RE: **Oasis Townhomes Planned Development
Application for Zoning Atlas Map Amendment (2 Parcels)
Applications for Development Review**

STAFF REPORT

PLAN CORRECTIONS REPORT #: 22-43900001

**RE : PD and Site Plan Oasis Townhomes at Hutchinson Island
901 and 1001 South Ocean Drive
3rd Submittal**

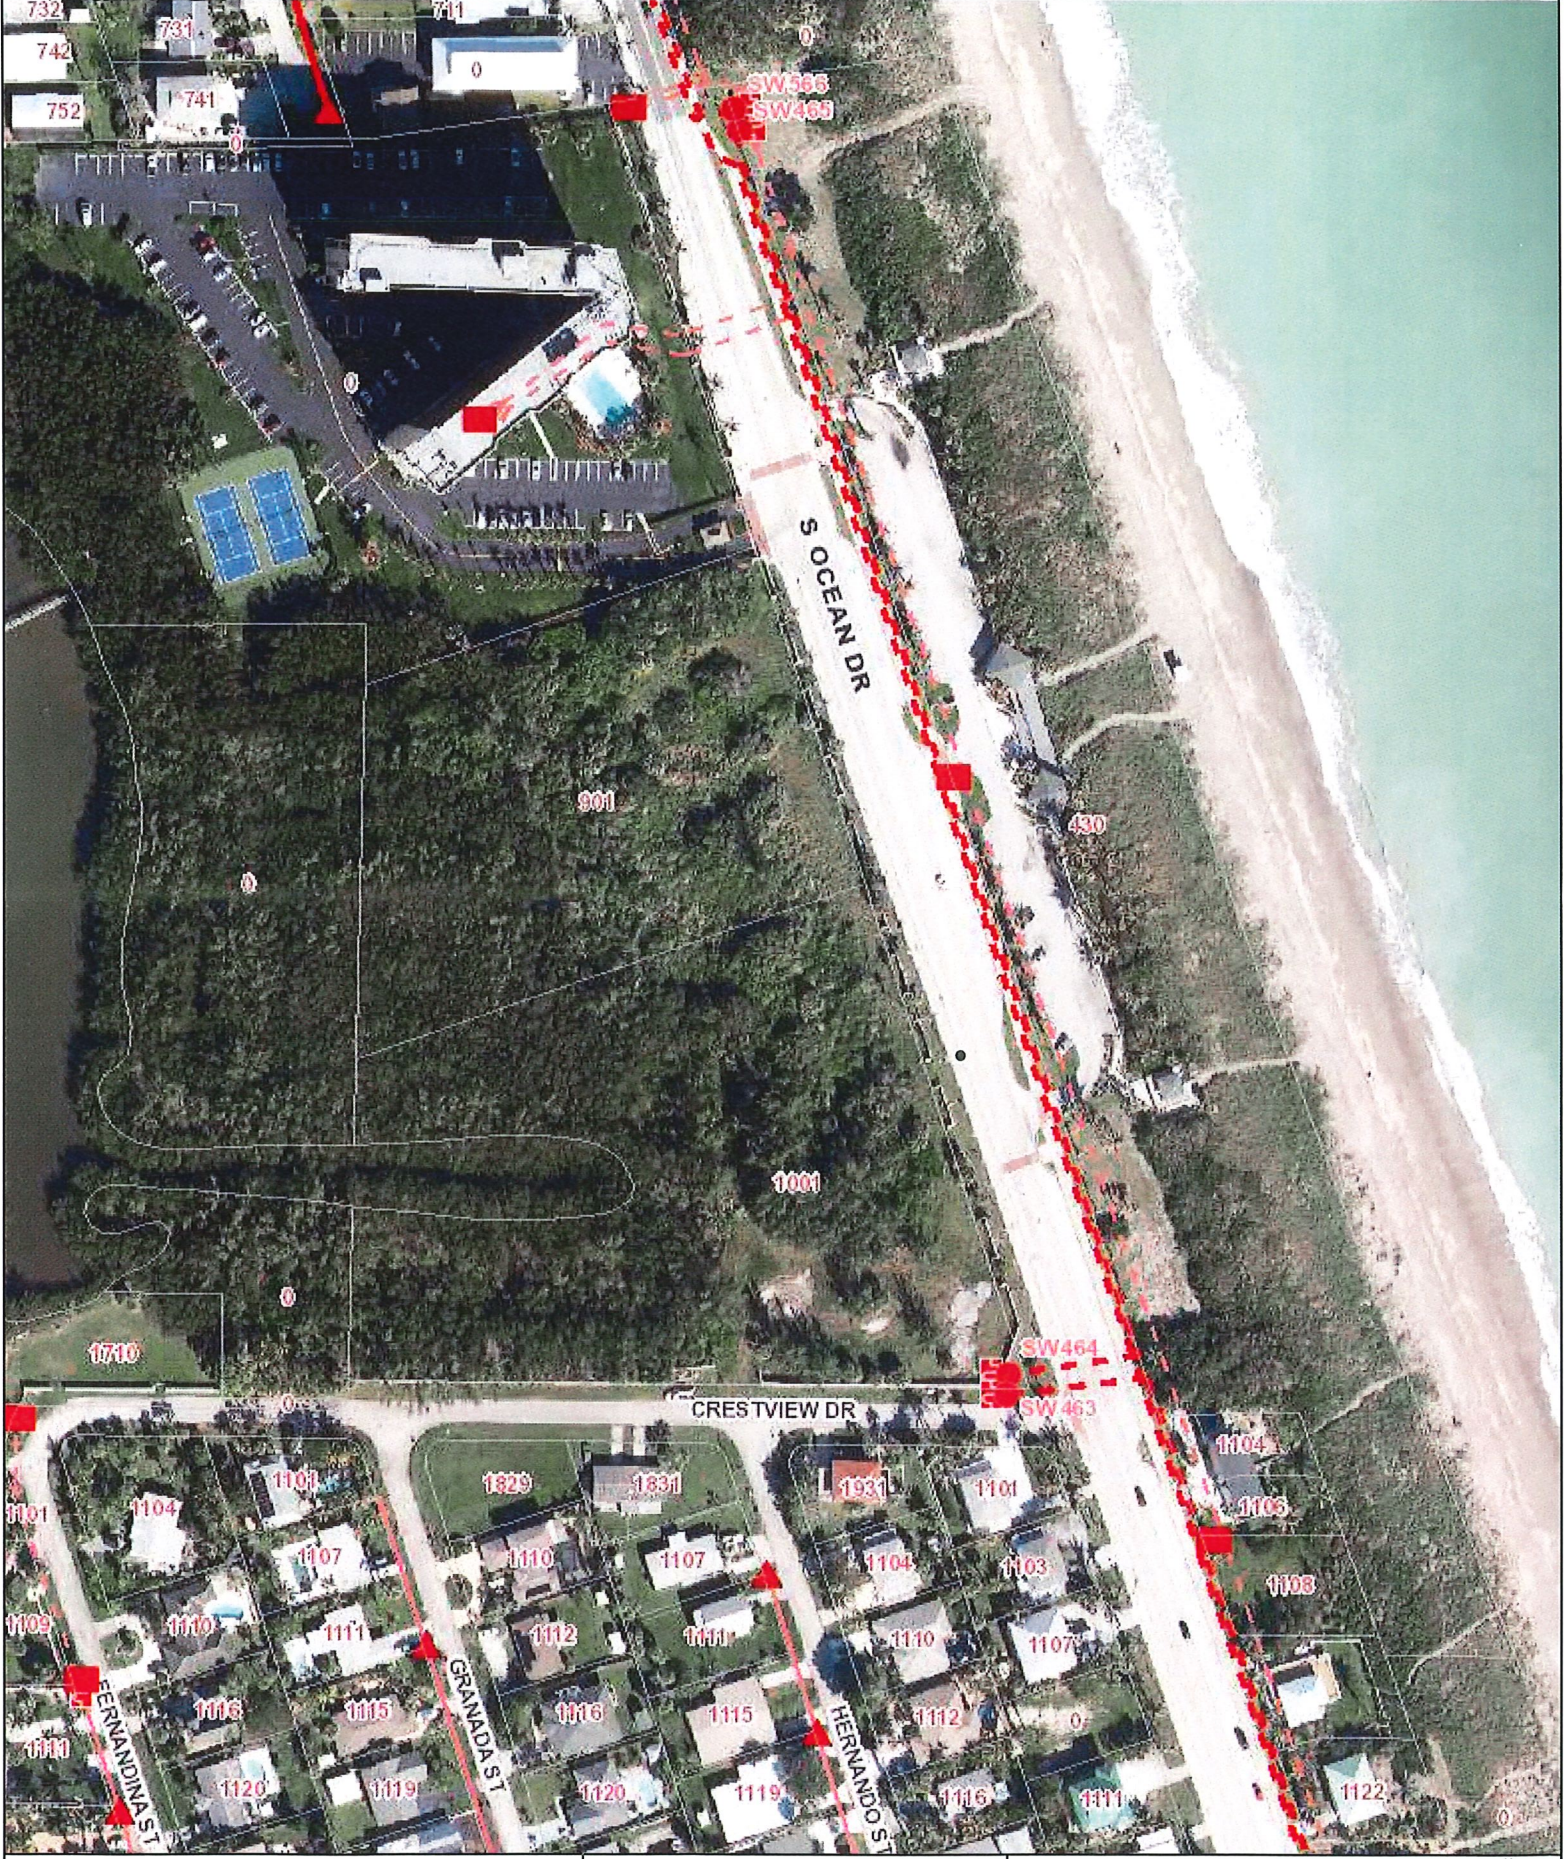
Electric service is available (from the NW corner of Crestview Drive and S. Ocean Drive) to the site. Please provide AutoCAD drawing. Customer will be responsible for the transformer pads, conduits and secondary conductors. For more information and project coordination, please contact Thierry Sydné.
